Addendum

PROJECT: Office Renovation and Addition for
City of Huber Heights Tax, Finance & Water Departments

ADDENDUM NO. 1

G0.2

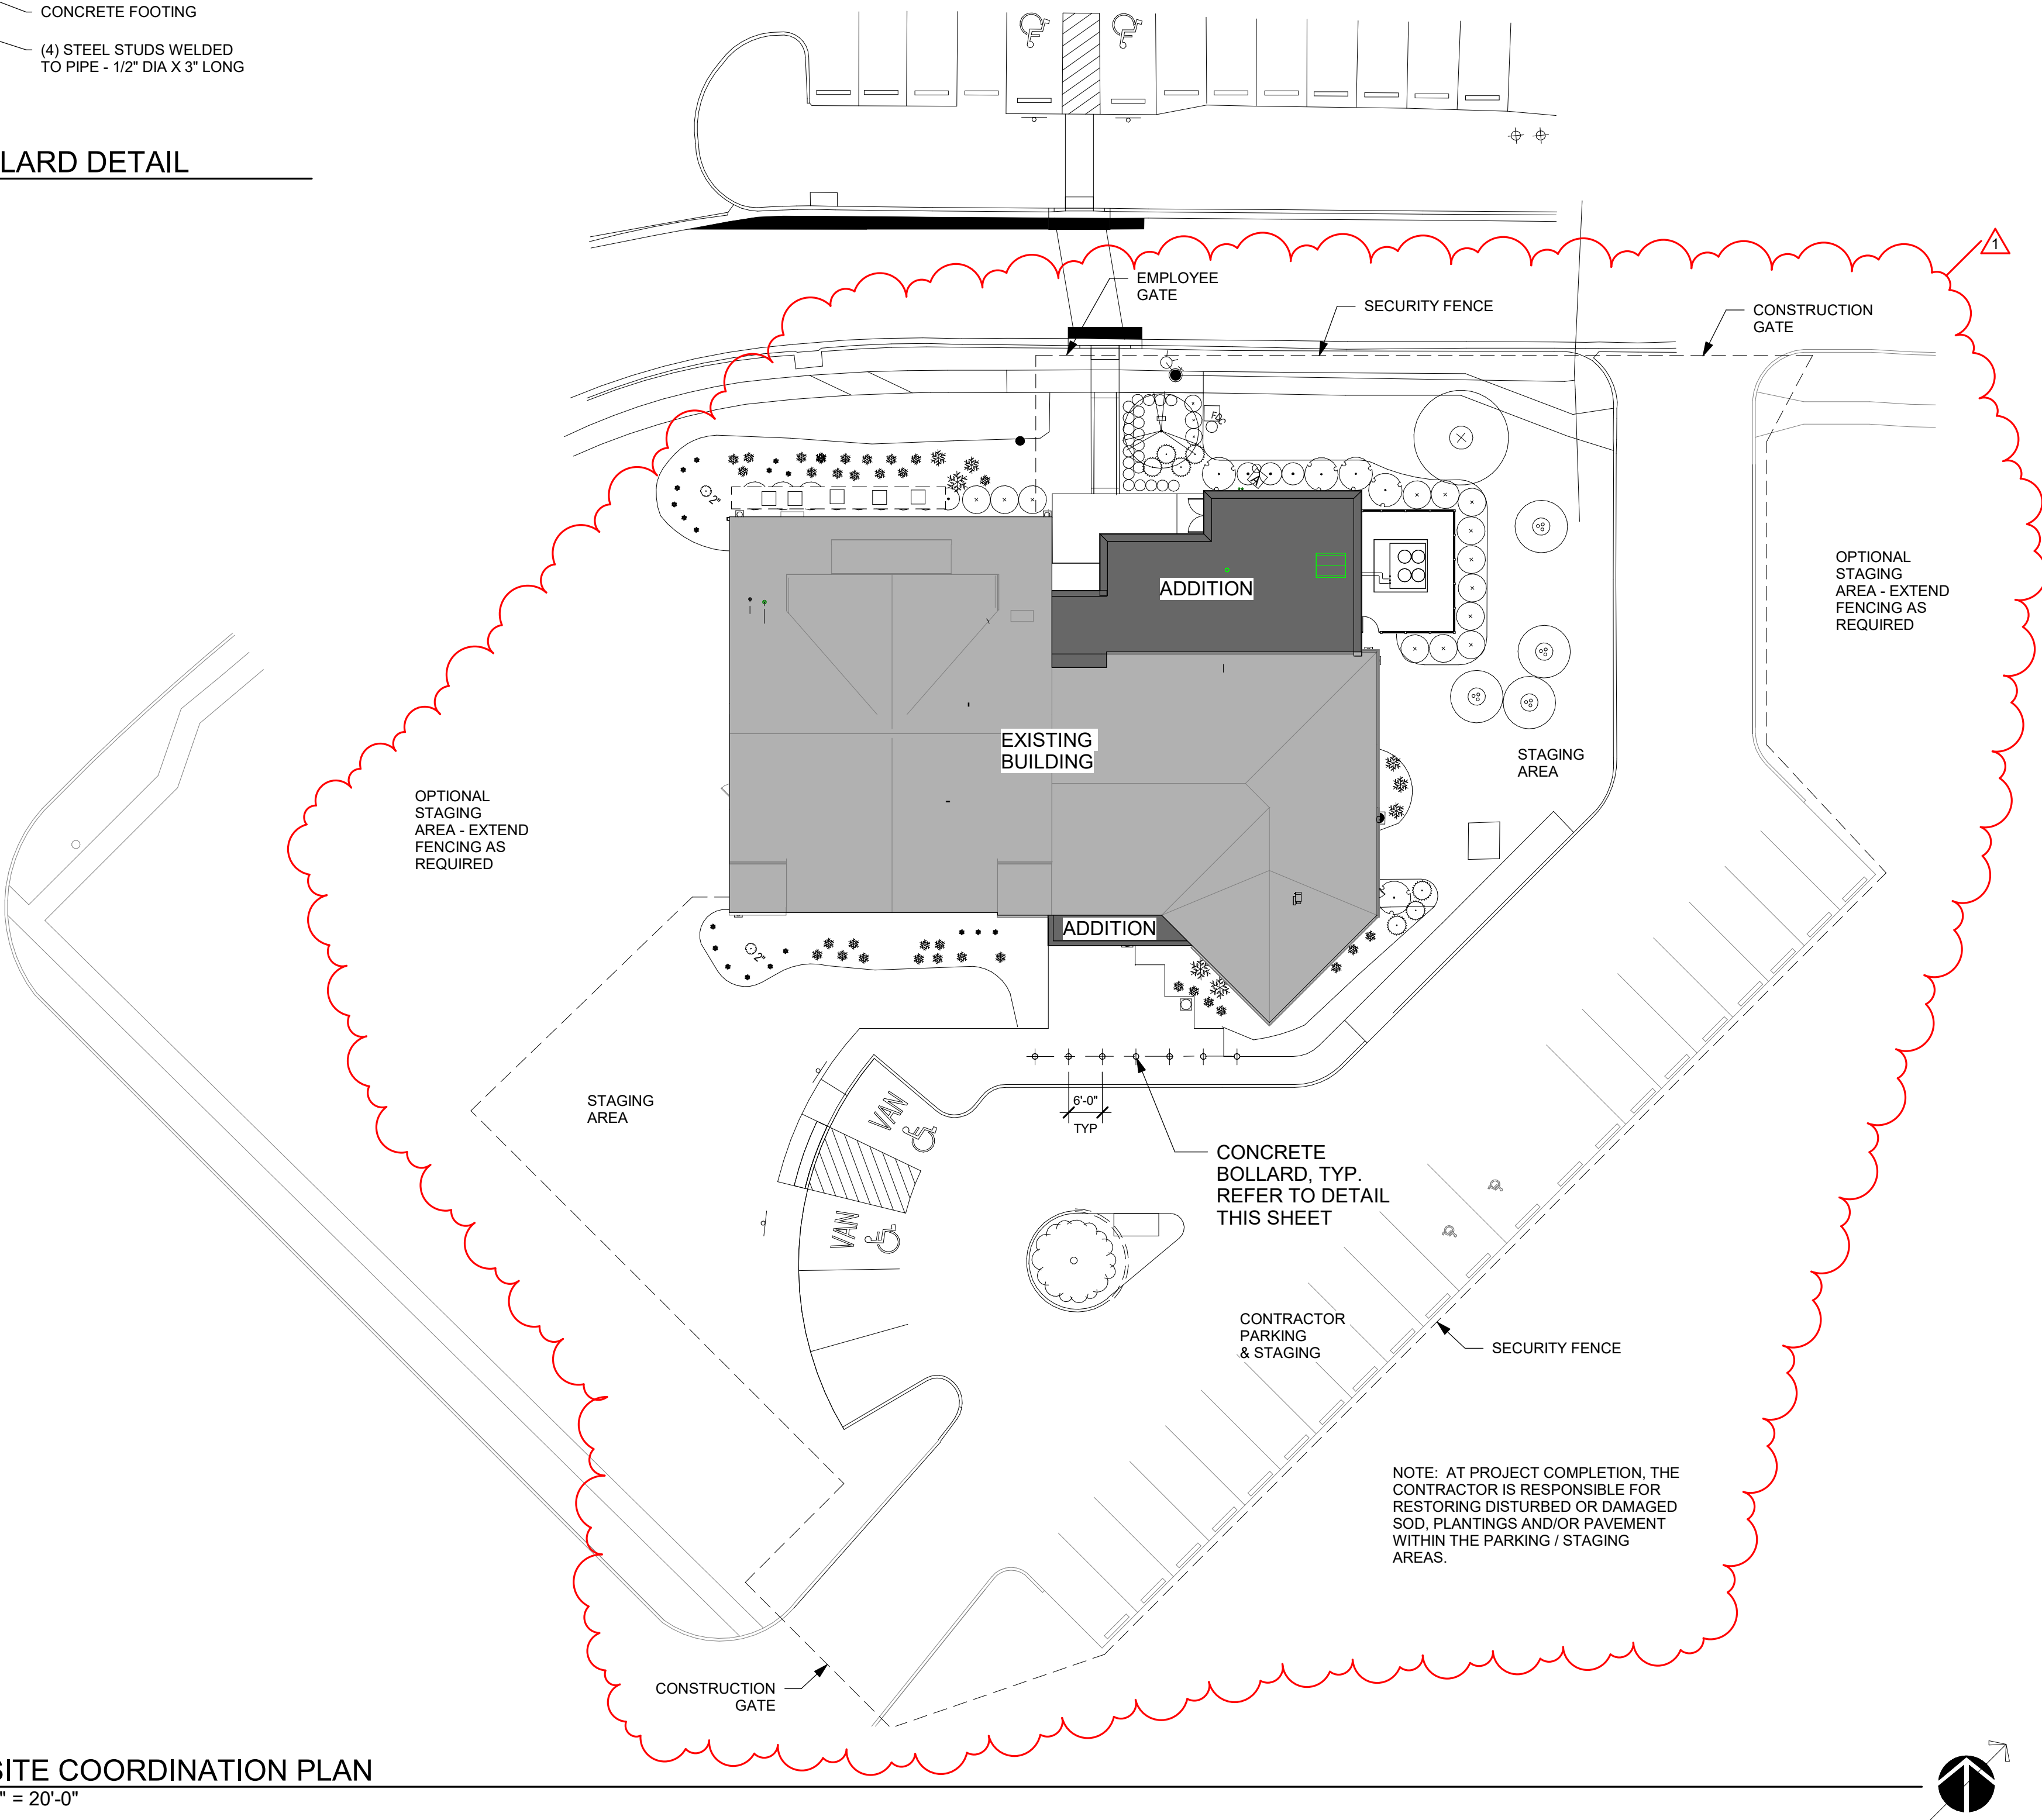
ITEM G1 DRAWING, G.02

1. Required security fencing, contractor parking and staging areas added to site coordination plan.

- Q3 Who is paying for builder's risk insurance?
- A3 The City will be responsible for providing the builder's risk insurance as stated in AIA A101 Exhibit A.
- Q4 What are the extents for security fencing and is there an area designated for staging?
- A4 Refer to revised drawing G0.2 included in Addendum 1.

E2.1

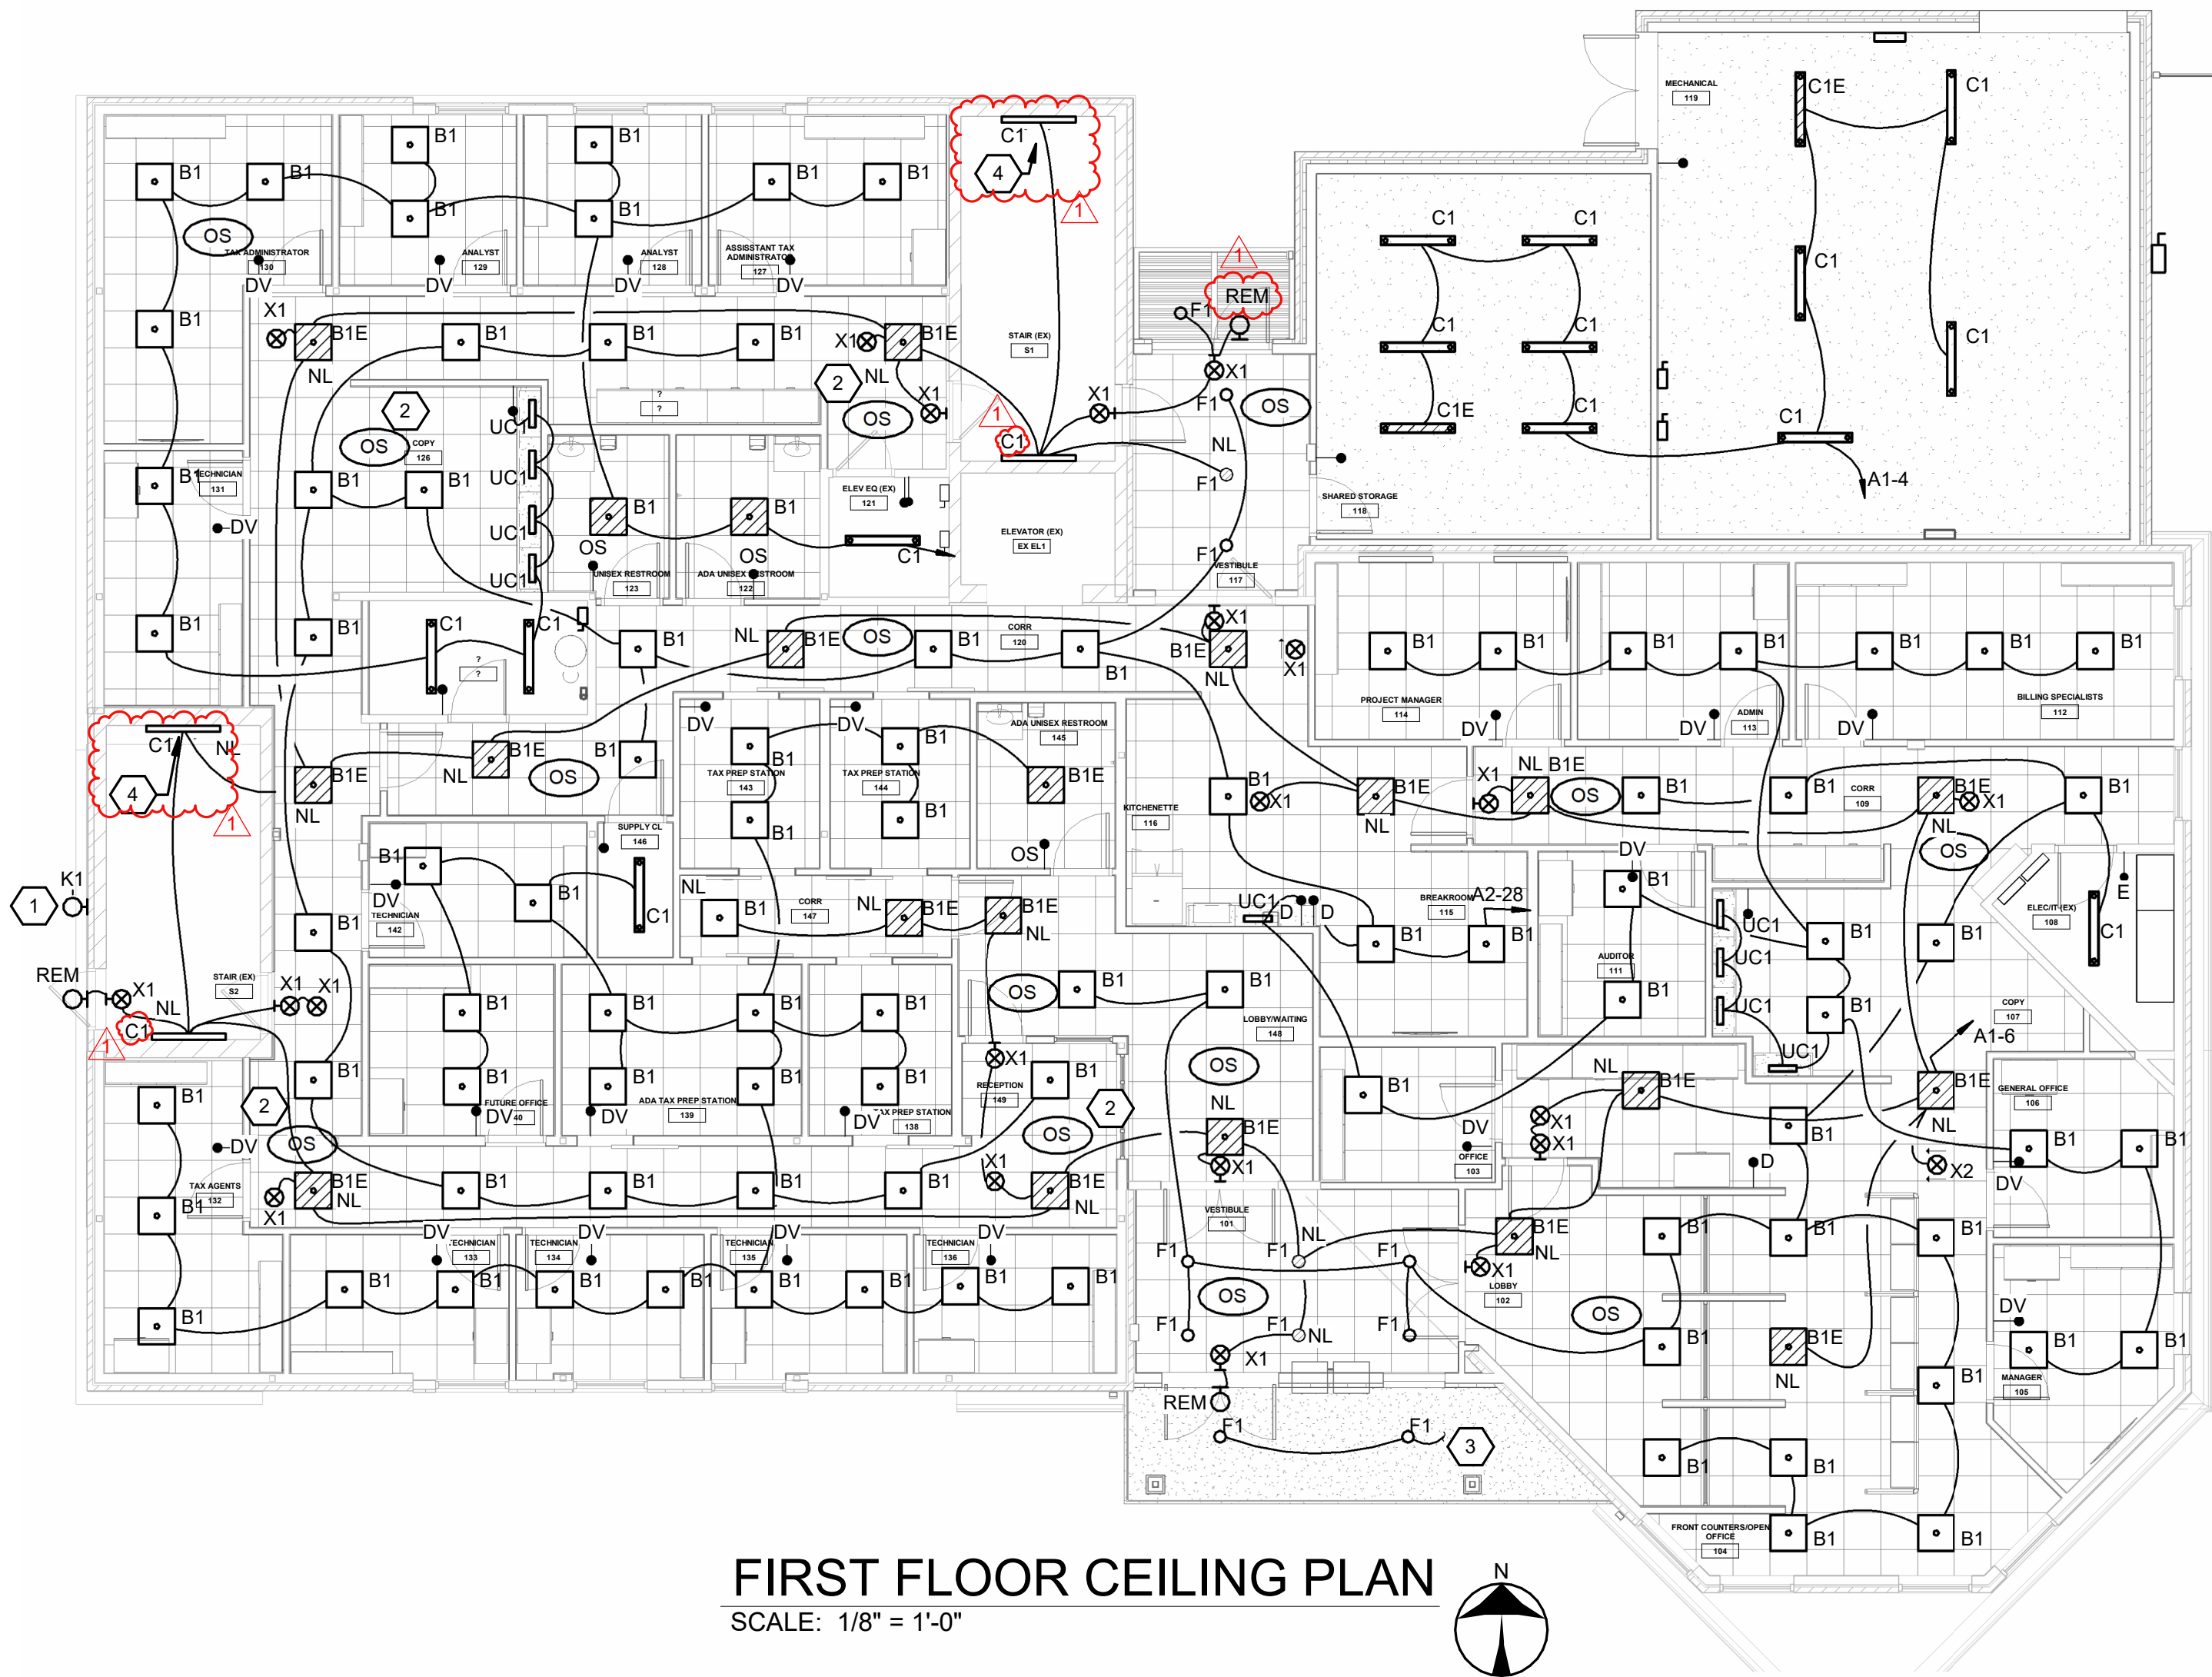
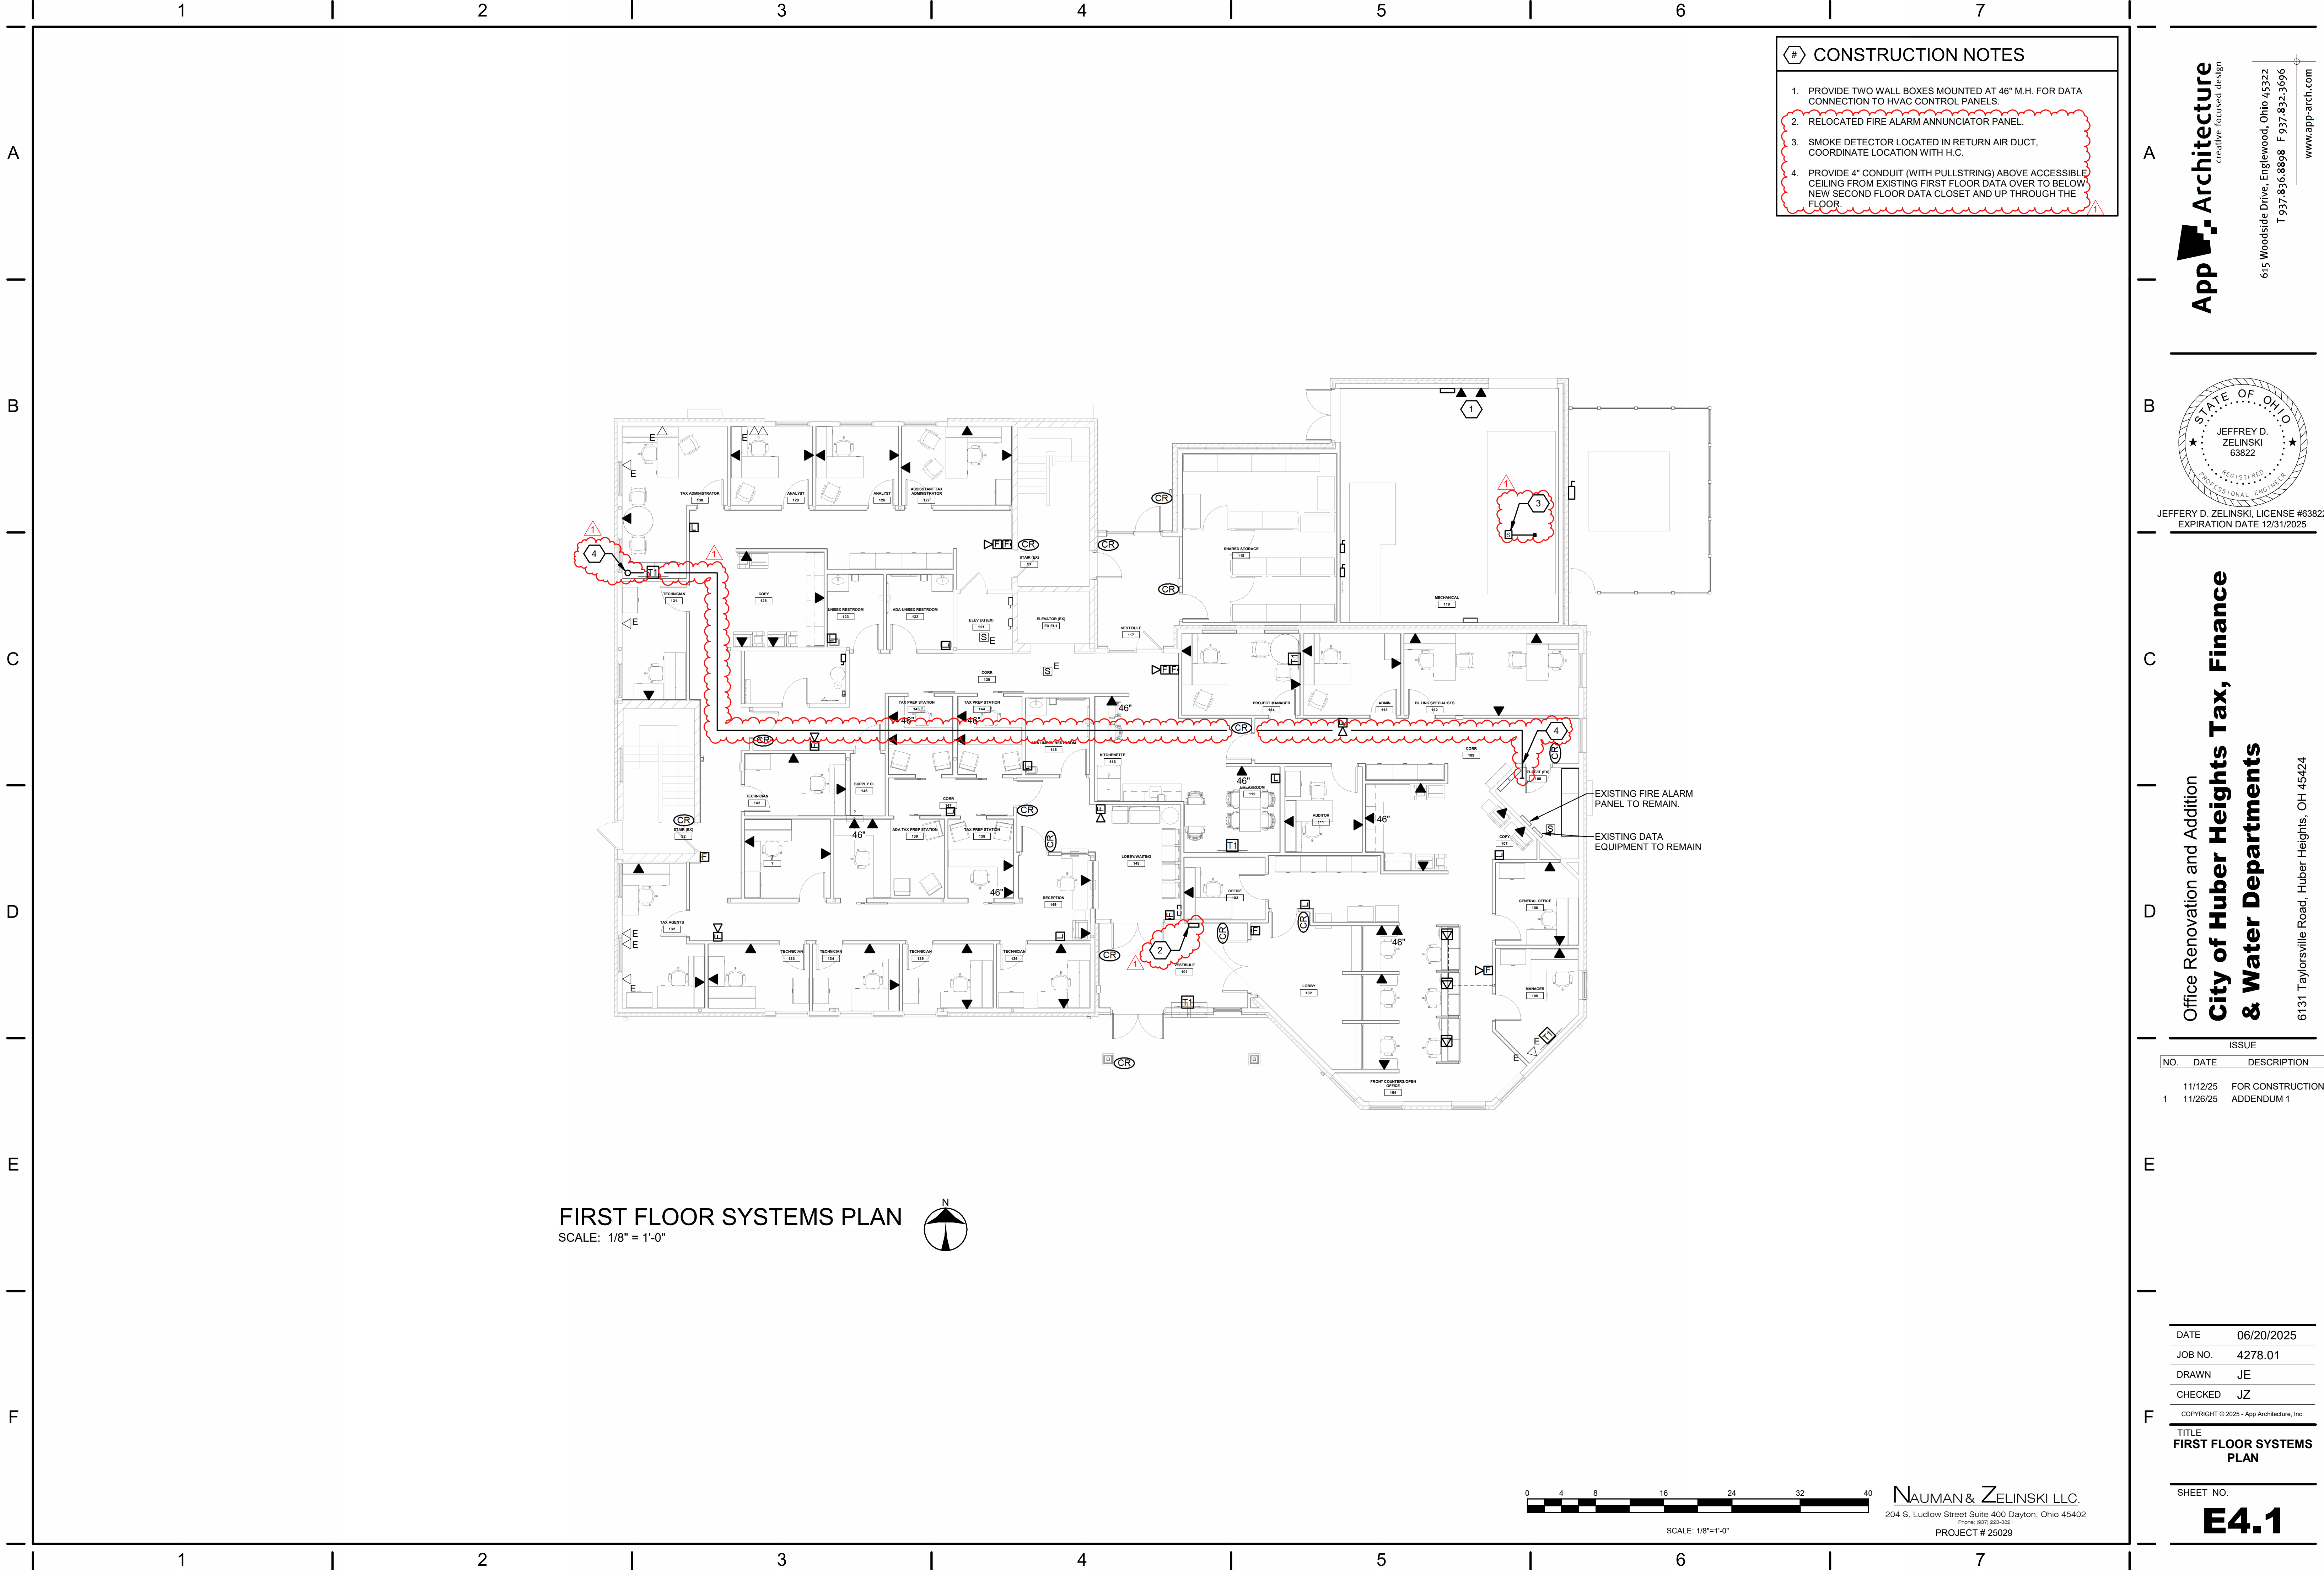
ITEM E2 DRAWING, E2.1

1. Modify light fixture tags, change Stair light fixtures to C1 there is no D1 fixture. Add label REM to fixture on north entry.
